YARRA CITY COUNCIL

Internal Development Approvals Committee

1.1 104 Mary Street Richmond - PLN18/0224 - Construction of three double-storey dwellings with basement car park.

1. This report provides Council with an assessment of Planning Permit Application PLN18/0224 which affects land at 104 Mary Street, Richmond and recommends approval, subject to conditions.

1.71 Site Shadow Analysis

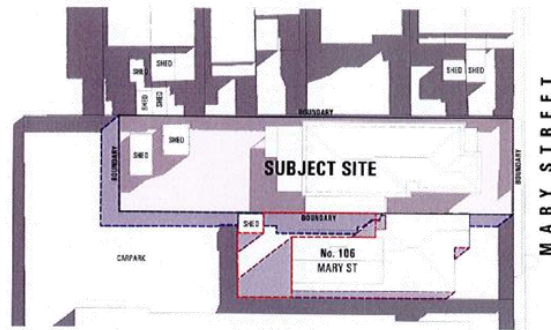
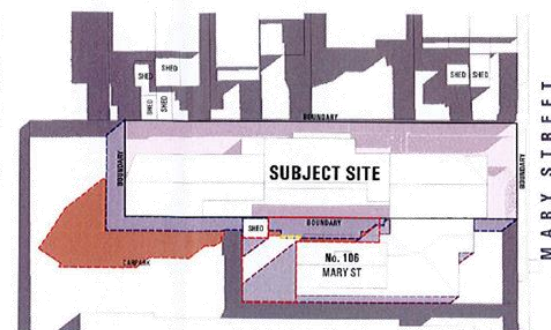
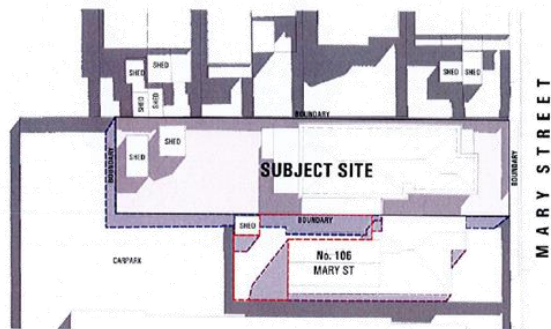
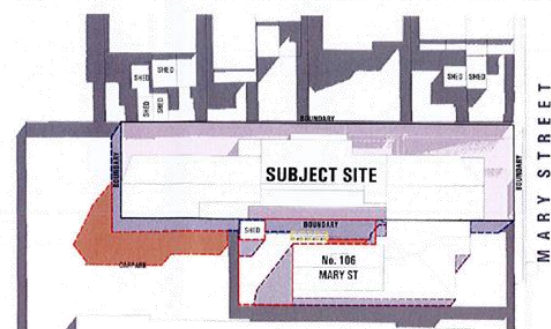
137. The only area of secluded private open space impacted by shadows cast by the development is that associated with the adjoining dwelling to the south, and this is only evident in the morning hours. The amended plans have further reduced the shadows cast to the secluded private open space of the adjoining dwelling to the south with the biggest improvement evident at 9am and 10am (i.e. a reduction of between 6-10sq.m.).

2.01 Basement Floor Plan

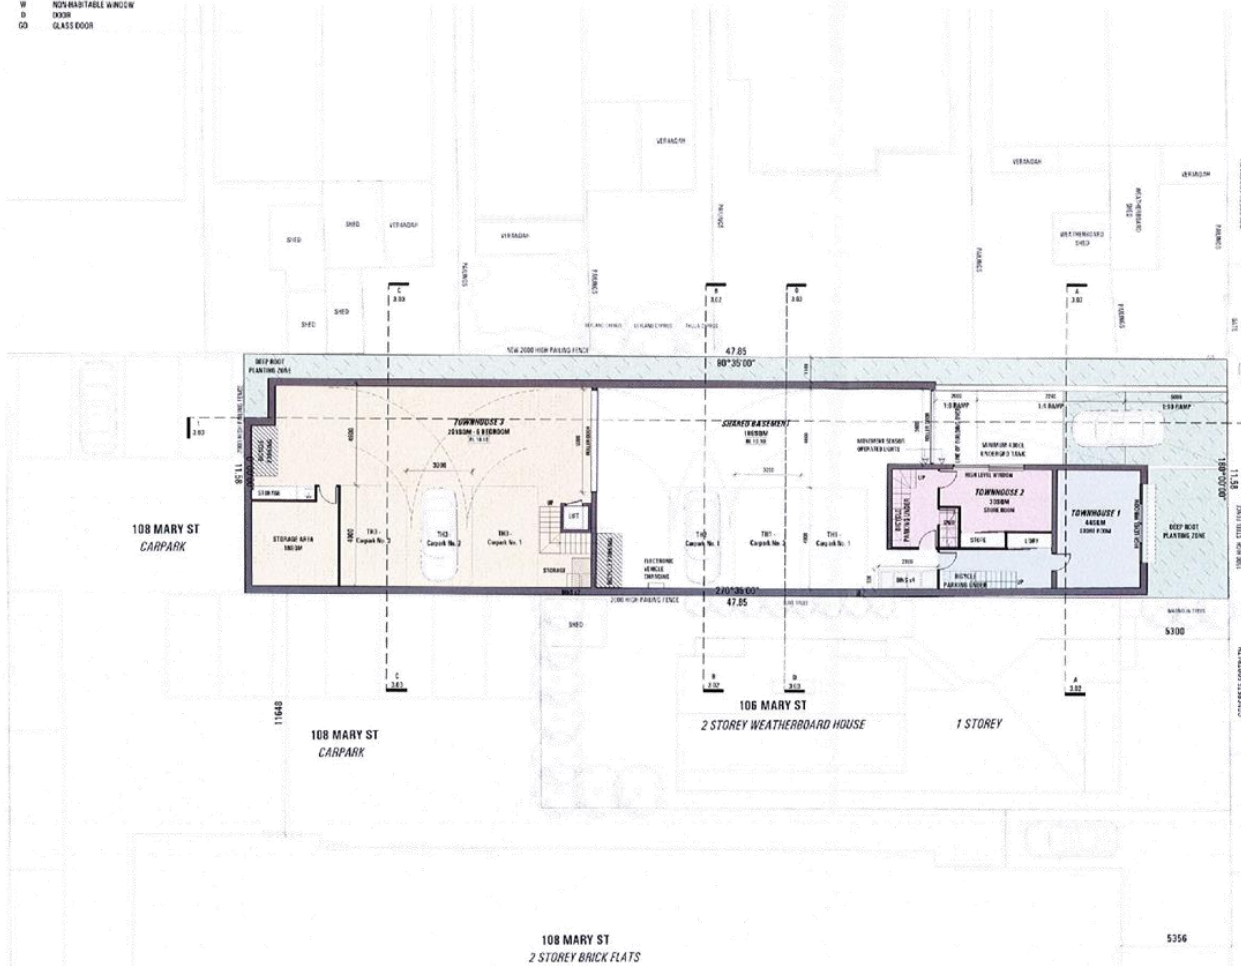
76. The amended plans were referred internally to Council's Engineering Services Unit due to the adopted basement setback from the northern site boundary that could impact vehicle manoeuvrability on site and vehicle turning circles. Further referral advice in relation to this component of the proposal was provided by Council's Engineering Services Unit (see Attachment 4, referral dated 29 March 2019).

120. The on-site car parking spaces are conveniently located for the future residents of the proposed new dwellings in the form of a basement car park. The design of the car spaces and manoeuvrability of vehicles shown on the amended plans (as a result of the basement setback from the northern site boundary) have been assessed by Council's Engineer and found to be satisfactory.

121. In their referral comments, Council's Engineer have asked for further detail. More specifically, they have requested that a convex mirror be provided on the southern side of the development's vehicle entrance in order to further improve the visibility and safety for pedestrians using the footpath. While they support the access and egress in principle, they also require the submission of a swept path diagram to demonstrate that a B85 design vehicle will adequately enter and exit the site from Mary Street. These items will be required by way of conditions.

Idle Architecture Studio Drawing No.TP 2.01 and TP2.02 Revision C dated 30 January 2019

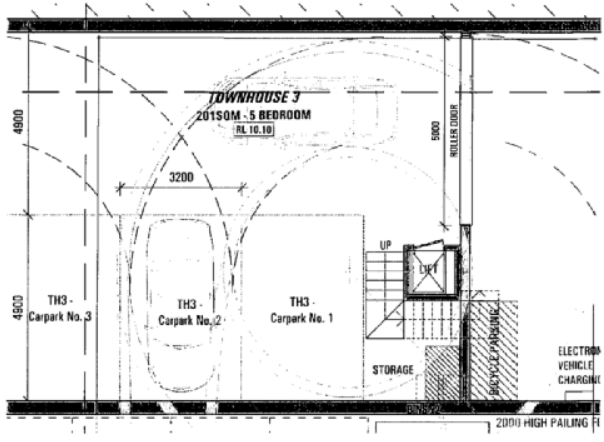
Item	Assessment
Car Parking Modules	
Vehicle Turning Movements Into and Out of Car Spaces
